pd-trigger-lite — Design Document

hwde v1 pipeline
generated 2026-09-24 03:39:11

ERC / schematic-review waivers (pd-trigger-lite, 2026-09-24, delegate)

Review waivers

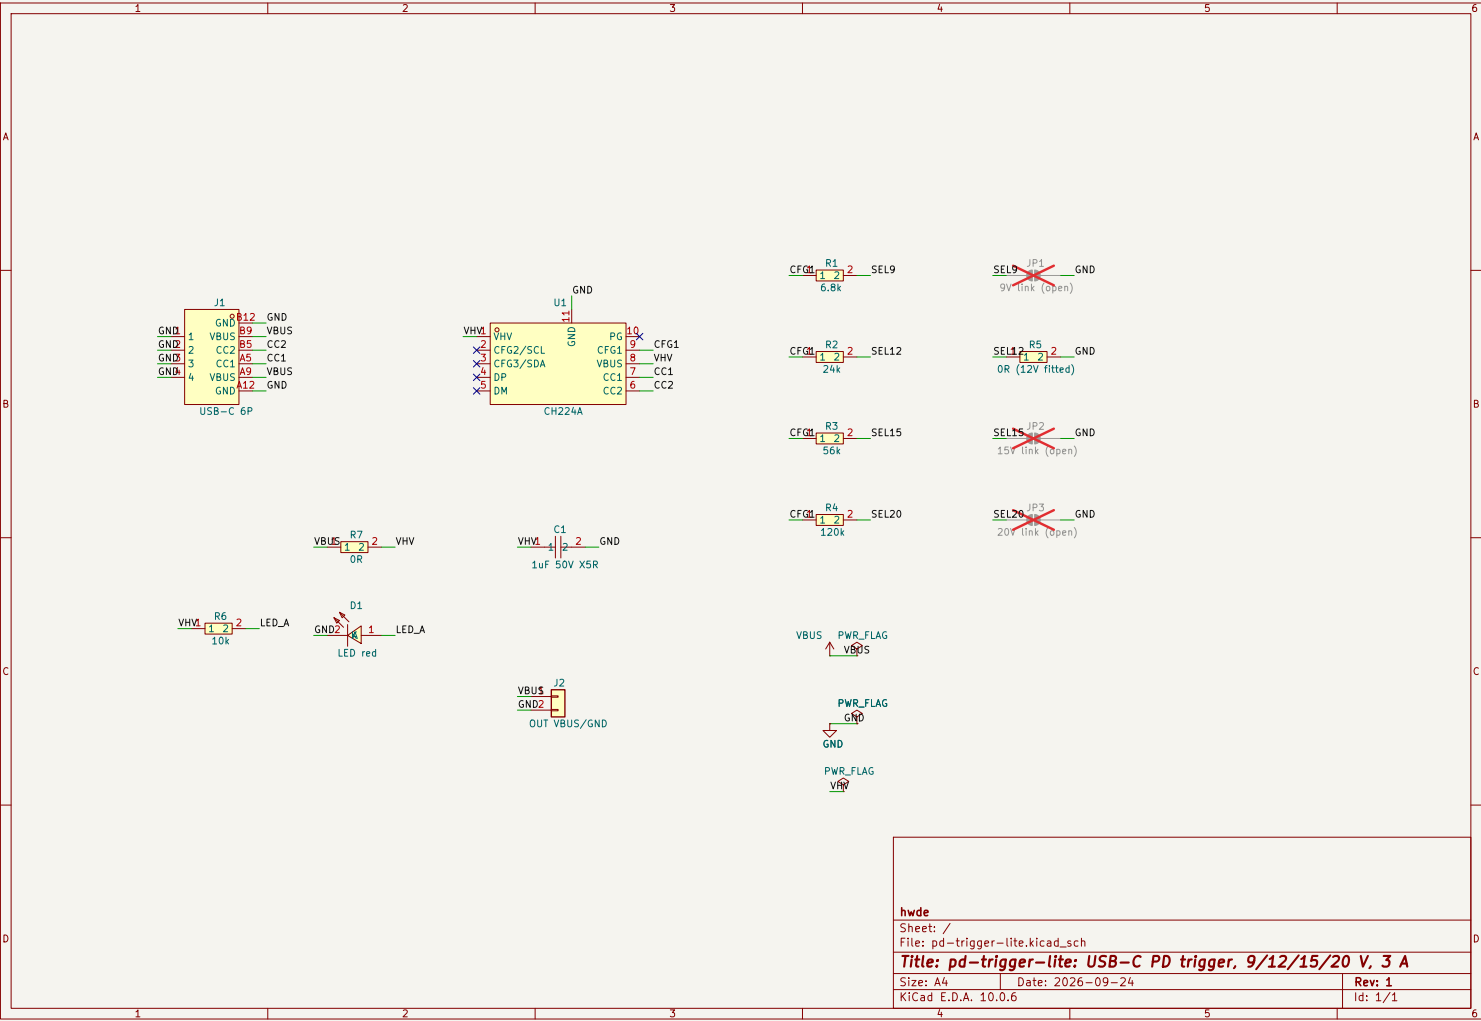
ERC: 0 errors, 0 warnings - nothing waived. Schematic review (`reports/review-schematic.md`), 0 errors, 2 warnings, both accepted:

- W1 no interlock for "exactly one link": zero links floats CFG1, two links parallel two Rset values. Accepted: the board ships with one link (R5) fitted; the guide and silk labels say move the one 0R. All links are now identical 0603 lands, so "relocate the 0R" is the natural rework.
- W2 no TVS/fuse/bulk against 20 V hot-plug ringing: decision D4 (datasheet requires none, brief says none). Disclosed in the guide.

Post-review edits (not re-reviewed, ERC re-run 0/0): R7 0R VBUS->/VHV split (width rule vs 1 mm pitch), JP1-3 moved from solder-jumper footprints to empty 0603 lands (DNP).
